FAIRLIGHT BOARDING HOUSE

195-197 SYDNEY ROAD FAIRLIGHT NSW 2094

S4.55 SUBMISSION

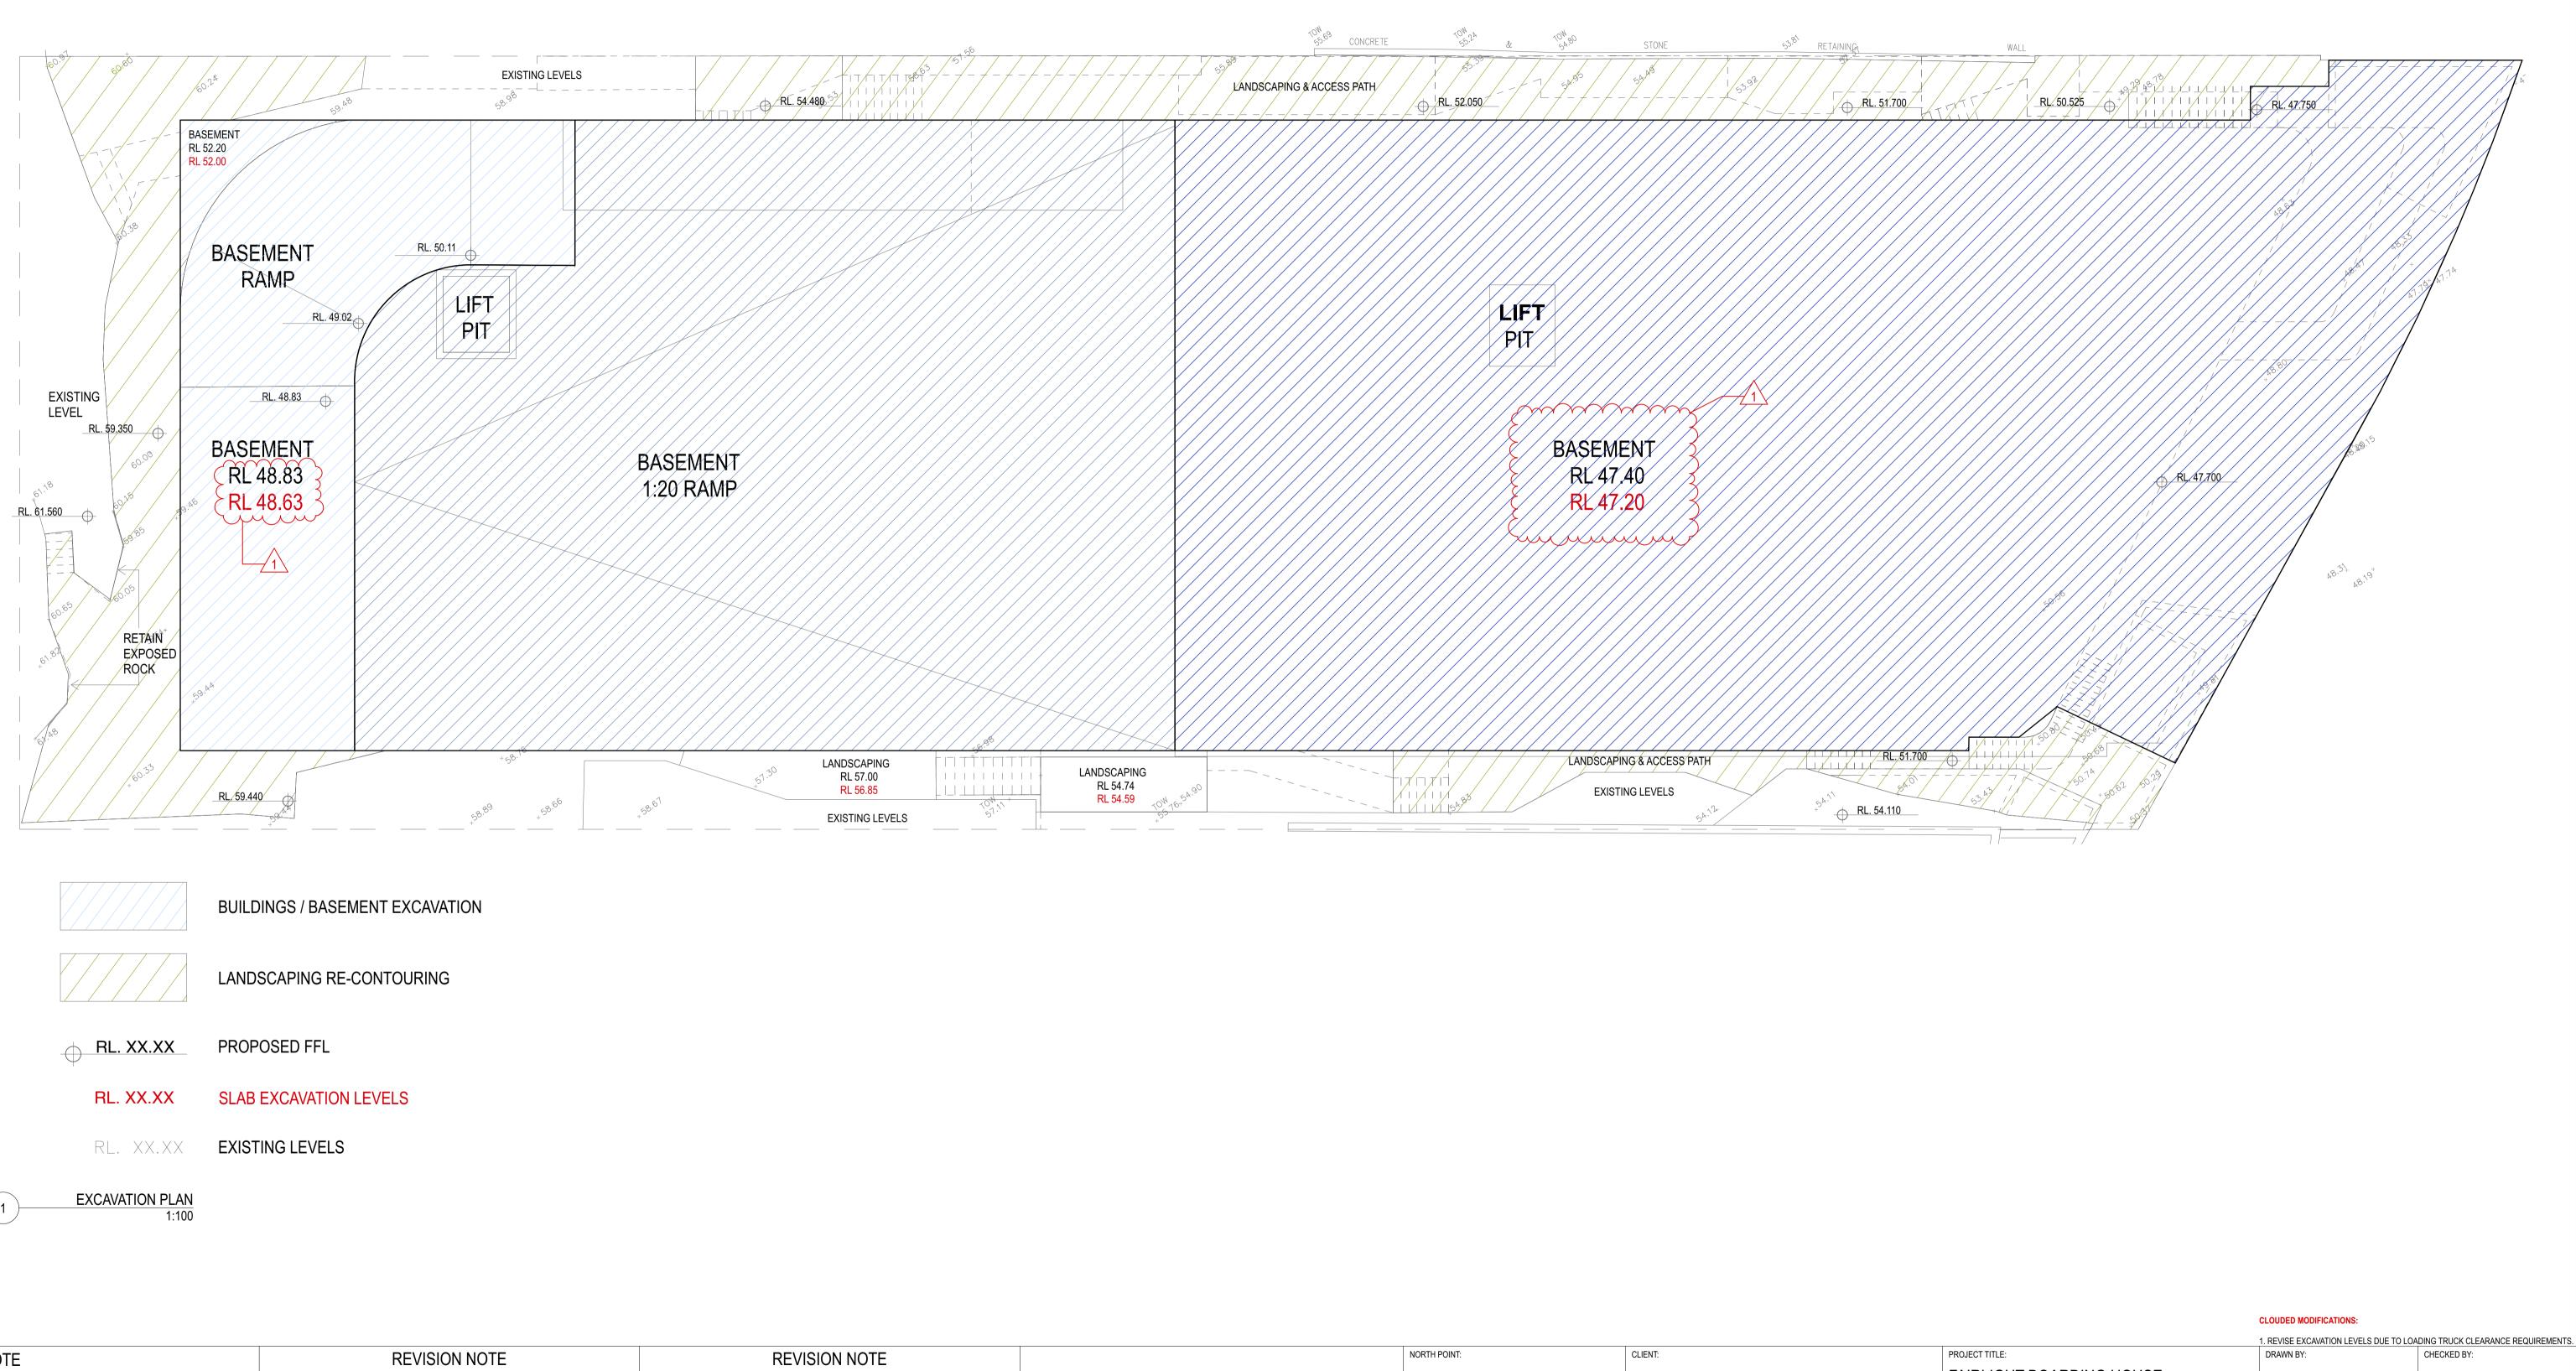
CLOUDED MODIFICATIONS:

1. FINISHES N₀. 7 AMENDED FROM SCREEN BLOCKS TO GLASS BLOCKS FOR FRL 90 MINS COMPLIANT.
